Access Compliance Report

Public Rights-of-Way

(Curb Ramps)

Intersection ID: 2932	Main Street: GREEN_HEDGE_AV	Cross Street: WINTER_PINE_LN	Location: NE
ADA ID: CE25E418DCED	Ramp Type: Perp	Initial Pass/Fail: Fail	Overall Compliance: No
Severity Score: 22.5			
Codes/Mitigation Info/Possible Solution		Field Measurements/Component Compliance

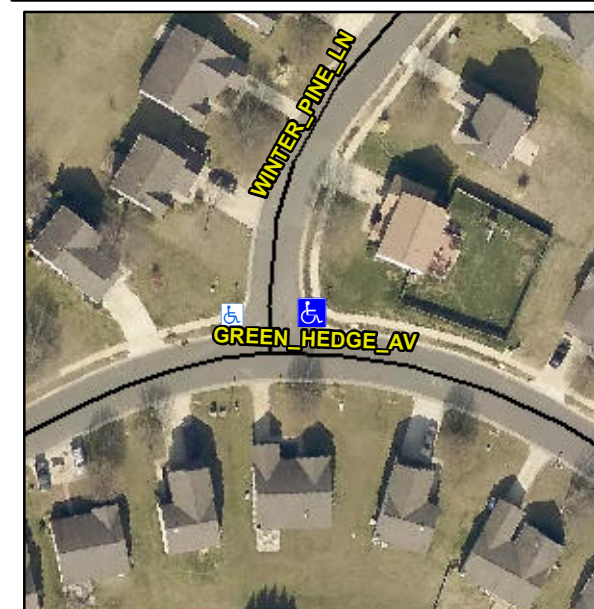
R304.5.1, R304.2.2, R304.5.3

Compliance	Description	Data	Compliance	Description	Data
N/A	Ramp Length (in)	48.0	No	Ramp Slope (%)	9.8
No	Ramp Width (in)	38.0	No	Ramp XSlope (%)	3.5
N/A	Flare Type LT	N/A	N/A	Flare Type RT	N/A
N/A	Flare Slope LT (%)	N/A	N/A	Flare Slope RT (%)	N/A
N/A	Flare Traversable LT?	N/A	N/A	Flare Traversable RT?	N/A
N/A	Landing Length (in)	N/A	N/A	DWS Provided?	N/A
N/A	Landing Width (in)	N/A	N/A	DWS Contrast?	N/A
N/A	Landing Slope (%)	N/A	N/A	DWS Length (in)	N/A
N/A	Landing X Slope (%)	N/A	N/A	DWS Full Width?	N/A
N/A	Landing Curb? (Y/N)	N/A	N/A	DWS Offset (in)	N/A
N/A	Shared Landing?	N/A			
N/A	Gutter Ponding?	N/A	N/A	Gutter Slope (%)	N/A
N/A	Gutter Lip Ht (in)	N/A	N/A	Gutter X Slope (%)	N/A
N/A	Painted X Walk1?	No	N/A	Painted X Walk2?	N/A
	X Walk 1 Direction	To W		X Walk 2 Direction	N/A
N/A	X Walk 1 Width (in)	N/A	N/A	X Walk 2 Width (in)	N/A
	X Walk 1 Slope (%)	0.8		X Walk 2 Slope (%)	N/A
	X Walk 1 X Slope (%)	2.0		X Walk 2 X Slope (%)	N/A

Remove & Replace Entire Ramp.
